To: All repair centres and production sites
Copy to: Anyone working with ND-120-CPU
From: Lasse Brataas
Date: 18 November 1994

Subject: NEW BACKUP BATTERY FOR THE CALENDAR ON ND-120-CPU

Detail of the logic diagram of print 3202.

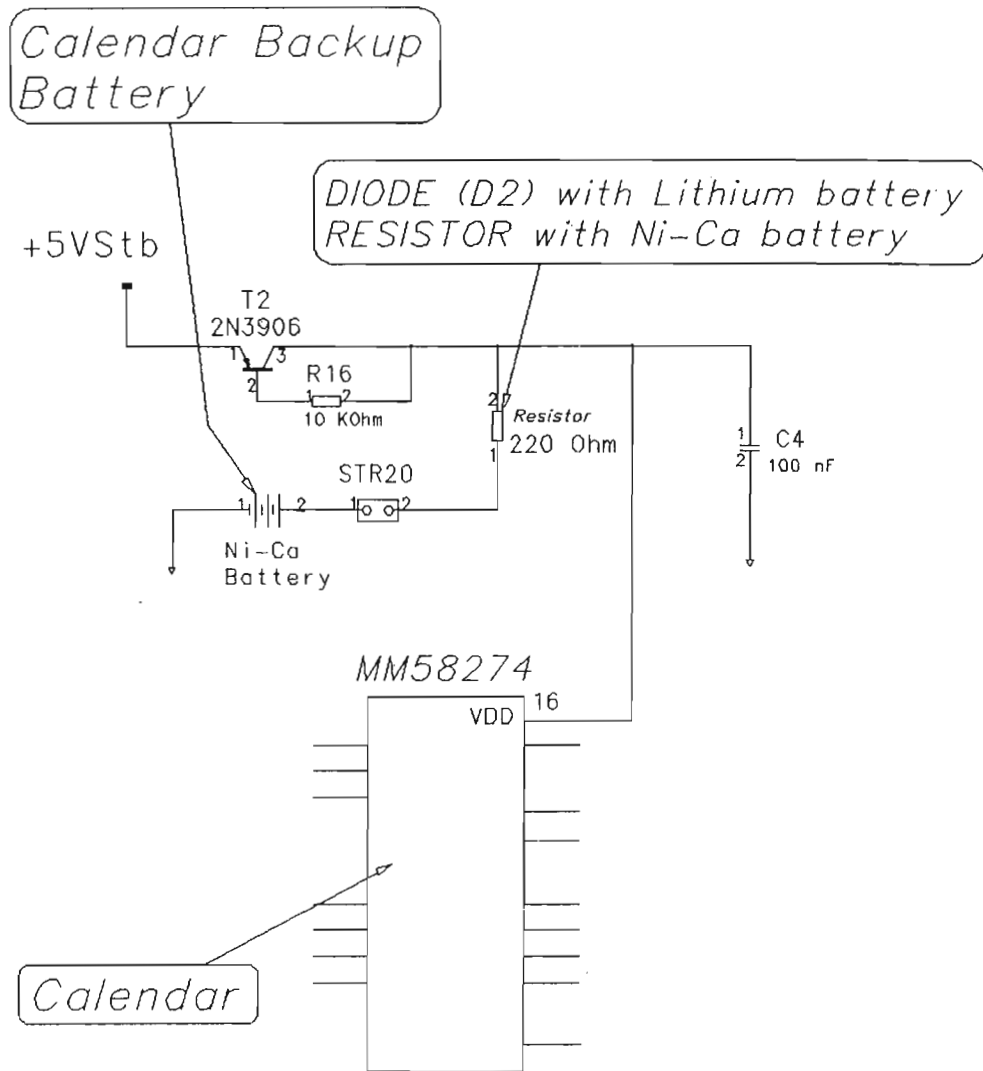
There will be a change in production of the ND-120-CPU from approximately the end of November this year. The calendar on the ND-120-CPU will be supplied with a new type of backup battery. The function of the backup battery is only to supply power to the calendar when the +5VStb is lost, such as during very long power-cut (more than 10 minutes), or when the CPU is in storage. See the detail from logic diagram on page 3.

The "OLD" battery has part number: 512022
The "NEW" battery has part number: 507040

The "old" battery is a Lithium battery, which means that it is not possible to charge and dangerous to try. This battery will supply power to the calendar for approximately two years with the CPU in stock. If the CPU runs in the crate the battery is not in use and it will therefore last longer. Since the clock is running while the CPU is in store the time and date shown may be correct, (summertime, time zone, etc.).

The "new" battery is a Ni-Cd battery, which means that it must be charged. This battery will supply power to the calendar for about one week with the CPU in stock. This means that the clock is probably not correct when you install the CPU in the crate, because the battery has been emptied while the CPU has been stored. A capacity of approximately one week should be more than enough to cope with even extremely long power failures.

WHEN THE CPU IS MODIFIED, (DIODE D2 IS REPLACED BY A RESISTOR), YOU MUST NEVER TRY TO INSTALL THE "OLD" BATTERY AGAIN. THIS WILL CAUSE CHARGING OF THE LITHIUM BATTERY WHICH MAY CAUSE A BIG EXPLOSION.
